# PERMIT

SITE INSPECTION SHEET

### MEMORANDUM

RE: Request for Emergency Inclusion in Metropolitan District  
10774 Judy Lane  
Riverside Estates, Lot 13, Block H

INDICATE NORTH. - NAME ADJOINING ROADWAY AS BASE LINE.

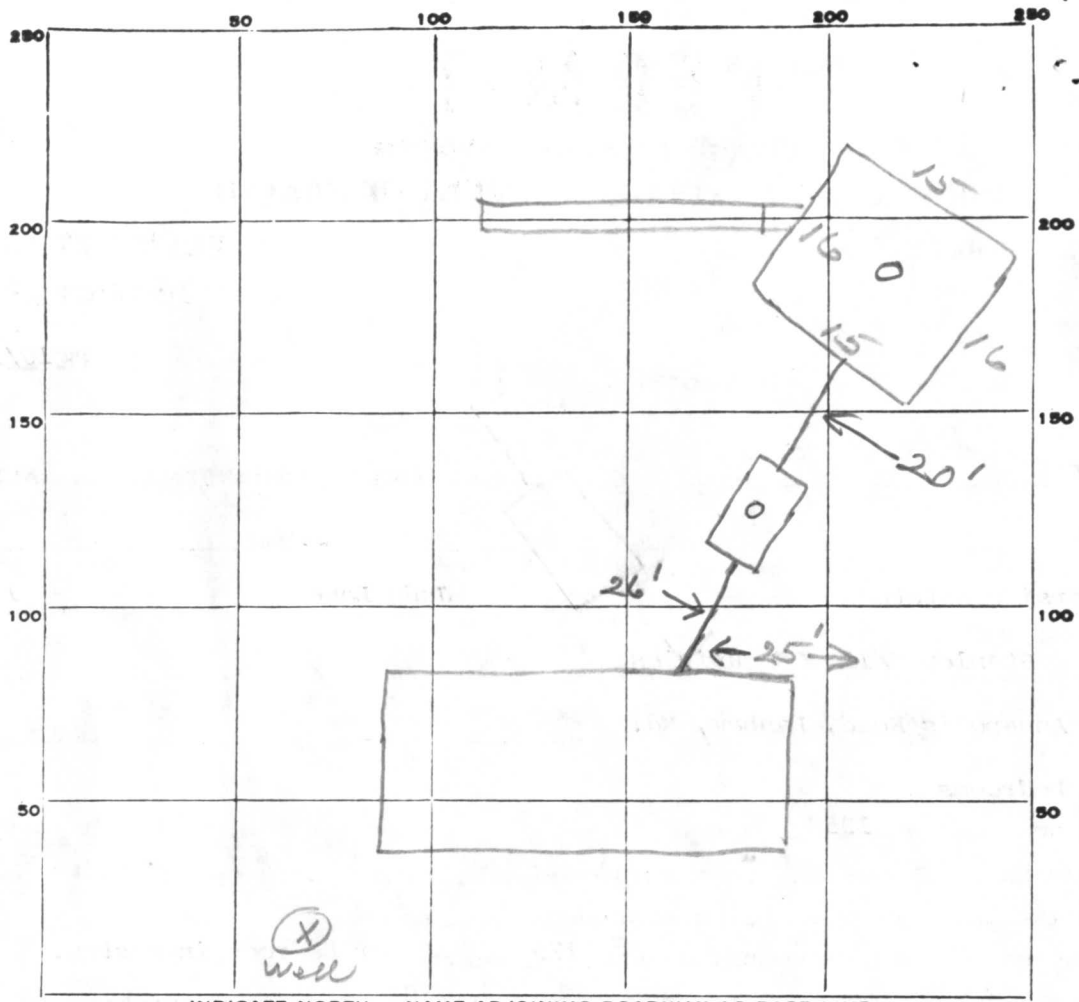
REMARKS 11/7/79 - OK to add gravel to trench - clean  
out of cast iron pipe needed. JS  
11/9/79 - OK to cover all work. JS

LOCATION DIAGRAM

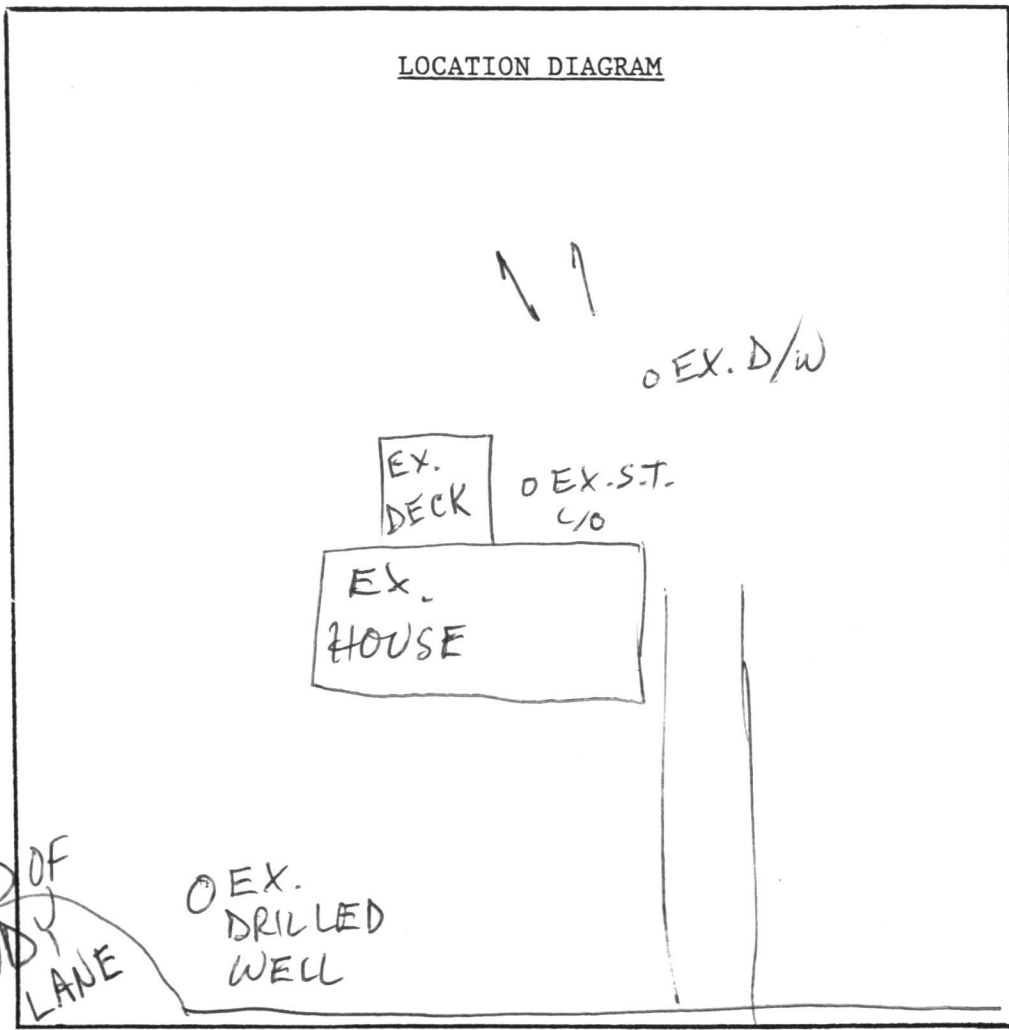
6/25/02 MET OWNER @ SITE; D/W SHOWS NO EVIDENCE OF FAILURE (H<sub>2</sub>O ~ 4' BELOW GRADE, NO DISCHARGE); IN ADDITION TRENCH EXISTS OFF D/W SO H<sub>2</sub>O @ THIS DEPTH IS EXPECTED, REQUEST FOR EMERG. INCLUSION IN METRO DISTRICT NOT SUPPORTED (FUR)
